David Scott Parker Architects

re: White House Complex, 1600 Pennsylvania Avenue, NW, Washington, DC. East Wing modernization and ballroom addition. Concept.

COMPARISON OF SCALE – SOUTH PORTICOS

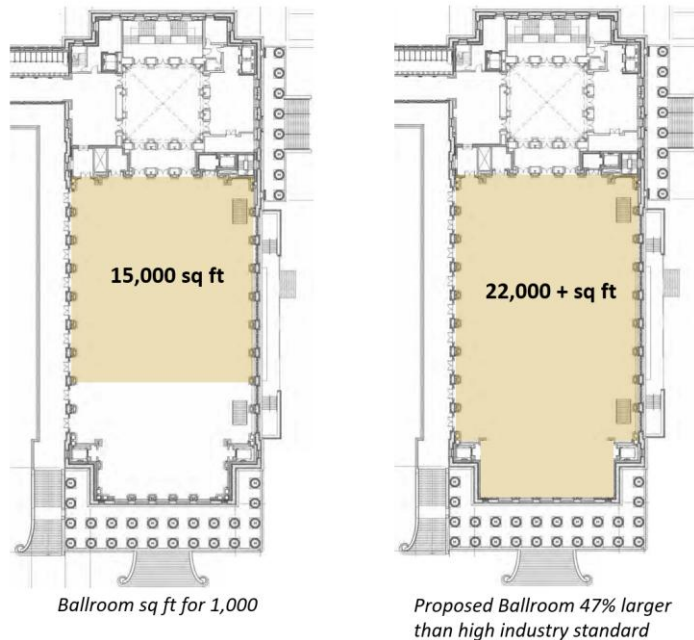
The scale of the proposed South Portico is too large; as is currently designed, the proposed ballroom South Portico is 166% larger than the current White House Portico and 40% larger than Treasury’s South Portico.

Ballroom – Proposed South Portico
121'-8" W x 71' H
*166% larger than White House South Portico
and 40% larger than Treasury South Portico*

PROGRAMMATIC CONSIDERATIONS

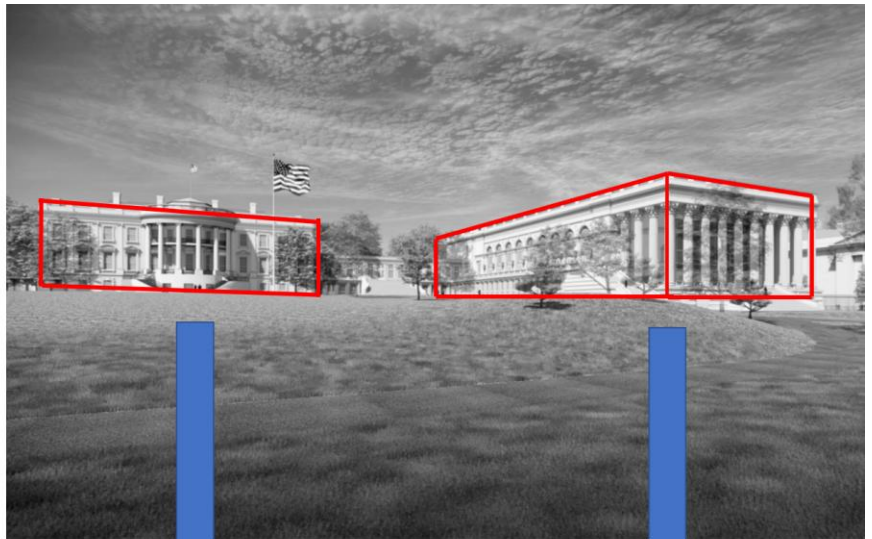
The architectural industry high standard space for ballrooms is 15 sq. ft. per person (and the low standard is 10 sq. ft. per person). The proposed ballroom is being designed for 1000 people, which means the ballroom should be 15,000 sq. ft. The proposed ballroom is estimated at 22,000 sq. ft, which makes it 47% larger than the industry high standard.

PROPOSED BALLROOM = 22,000+ SQ FT

Architectural industry high standard space for ballrooms is 15 sq ft / person or 15,000 sq ft for 1,000 people.

Ballroom as proposed is **47% larger** than high industry standard.

VOLUME / MASSING

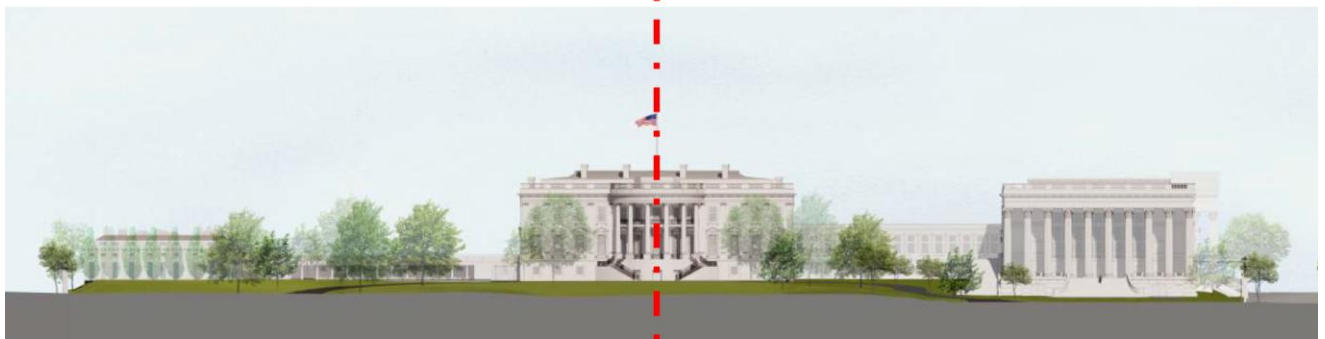
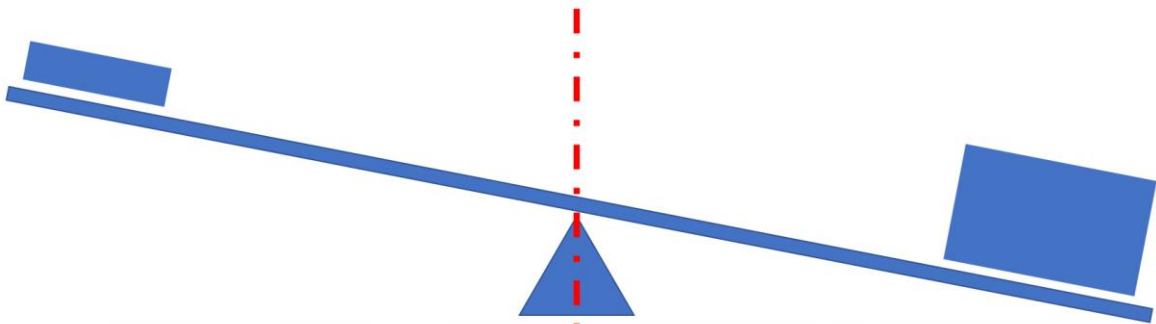
The current ballroom structure is estimated at approximately 2.36 million cubic feet. The original White House structure was approximately 794,000 cubic feet. Square footage comparisons can be misleading regarding the overall size of a structure; however, in this case, the proposed ballroom massing is nearly three times the original White House volume. The volume and oversized massing challenge the classicism on which the White House is based. Classicism is predicated on balance and symmetry, and the central main structure should always be the largest.

Square footage comparisons can be misleading regarding the overall size of structures. Note that the proposed Ballroom *massing* is nearly **THREE times** the original White House volume.

875 thousand cubic feet
(+ 41 thousand cu ft of portico volume)

2.36 **million** cubic feet
(+ 284 thousand cu ft of portico volume)

Plan and Section of south portion of proposed Ballroom

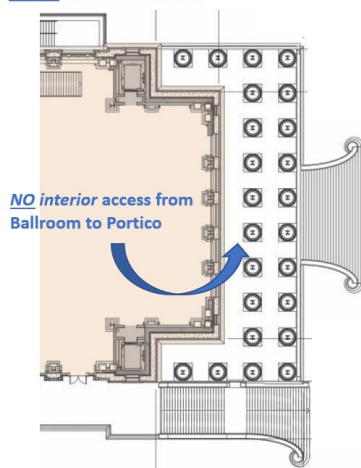
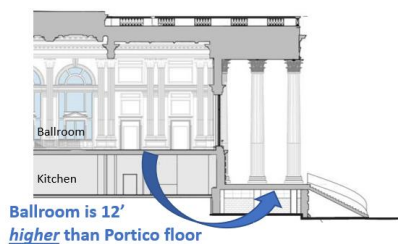
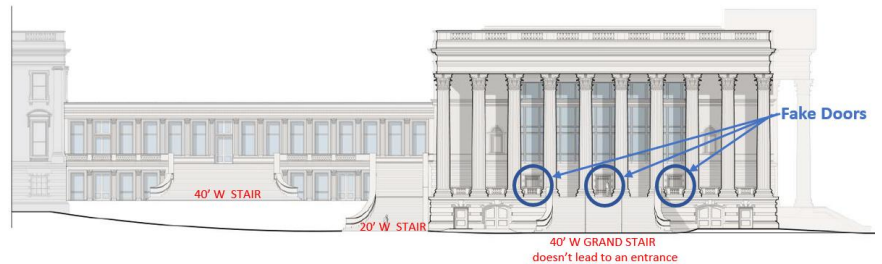
The 4,000 sq. ft South Portico as designed has no access whatsoever to the interior and is not ADA accessible. The doors shown on its South Elevation are fake. The massive grand staircase leading to it is gratuitous with no function or purpose. Lastly, the South Portico contains (24) 5-foot diameter columns that only block views from the interior.

- Has **NO ACCESS** whatsoever to interior and is **not ADA accessible**
- Doors shown on its South Elevation are **FAKE**
- Massive grand stair leading to it is gratuitous with no function
- Has (24) 5-foot diameter columns that only block views from interior

BUILDING COMPLETELY BLOCKS AXIAL VIEWSHED

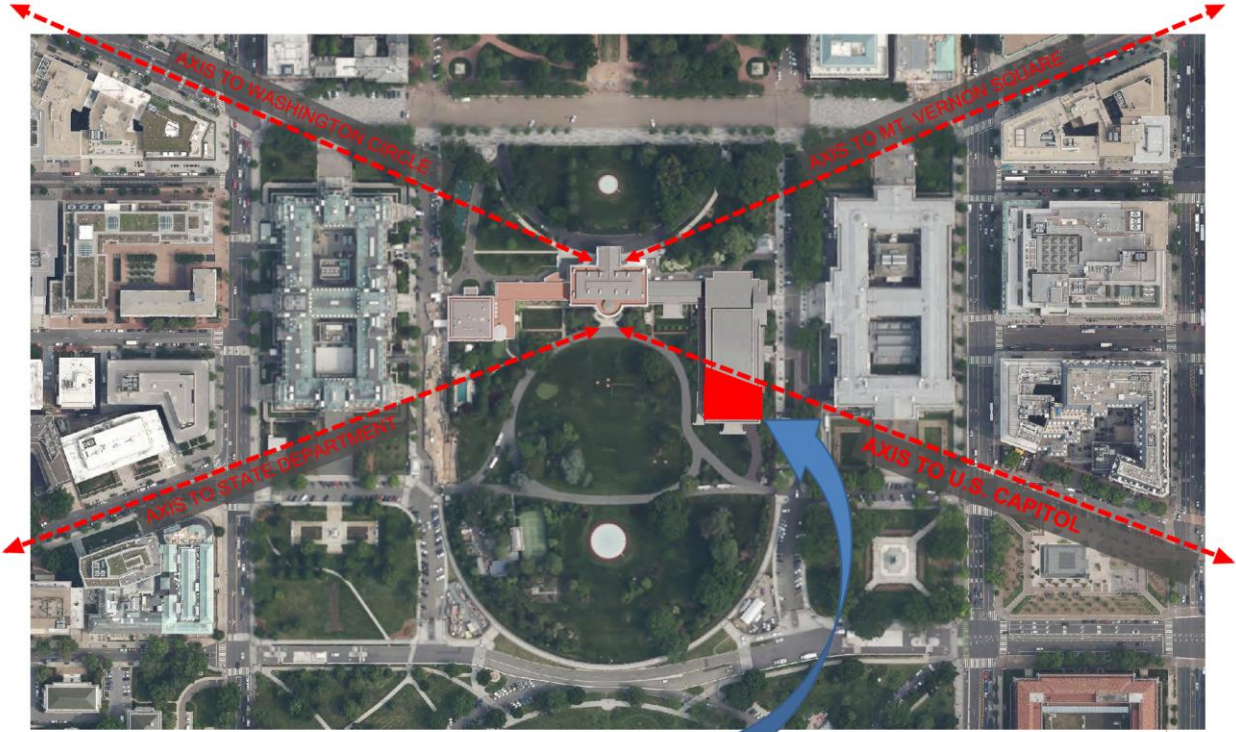
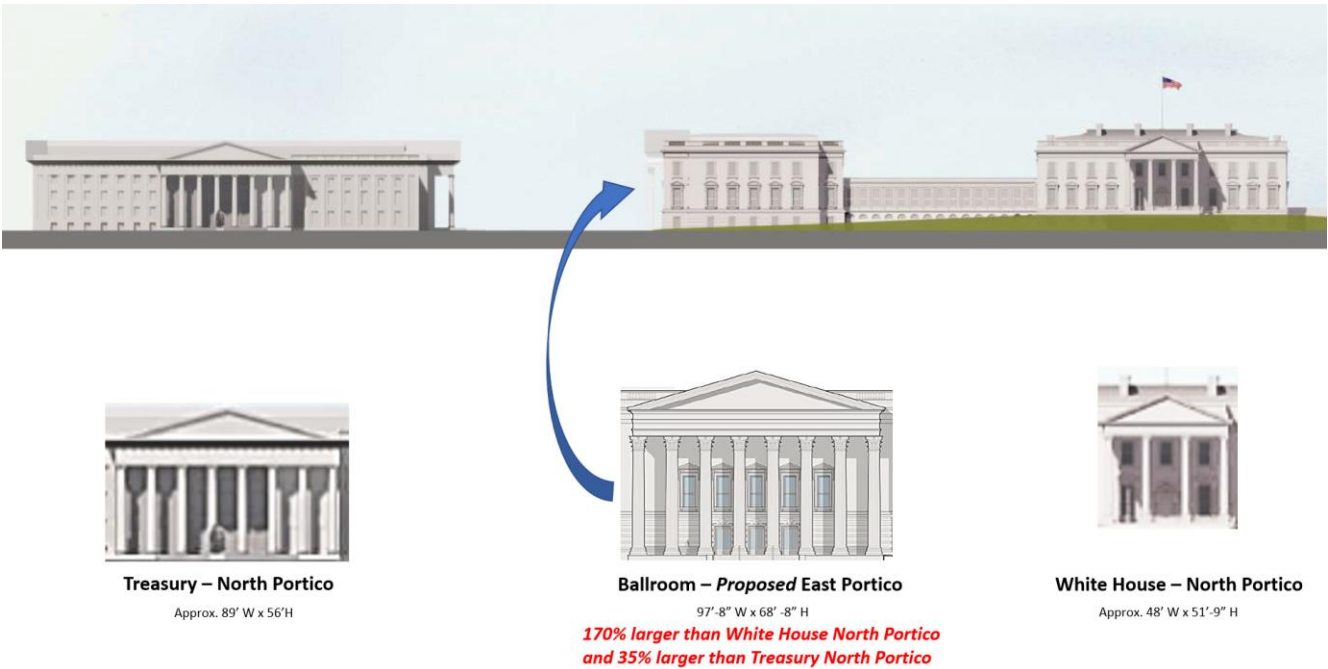
The original vista of the White House conceived by L'Enfant and our founding fathers would be blocked and restricted with the construction of the ballroom as proposed. The axial vista from the US Capitol steps looking northwest up Pennsylvania Avenue is one of the most important views and relationships in L'Enfant's original 1791 design for Washington, DC.

VIEW FROM CAPITOL STEPS TO WHITE HOUSE COMPLETELY BLOCKED BY NEW BALLROOM

MAJORITY OF FUNCTIONS NOW SHOWN ON LEVEL 1 COULD BE PUT BELOW GRADE

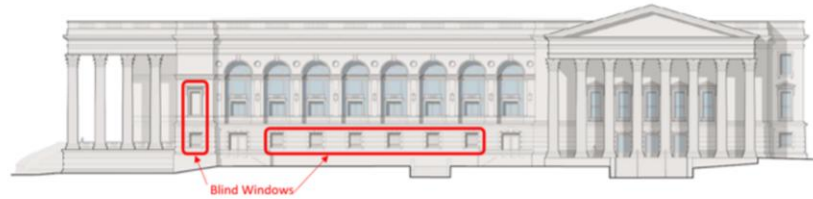
Most spaces now shown on the primary entrance level are service (non-public) support and do not need daylight or to be above grade. Note that the kitchen areas as shown are immense (13,000 sq. ft.), more than 2 ½ times the industry standard to serve the proposed 1,000 guests. This creates the opportunity to lower these functions below ground and reduce the overwhelming height of the building.

Most spaces now shown on the primary entrance level are service (non-public) support and do not need daylight or to be above grade.

Note also that the kitchen areas as shown are immense (13,000+ sq ft), more than **2½ times the industry standard to serve 1,000 people.**
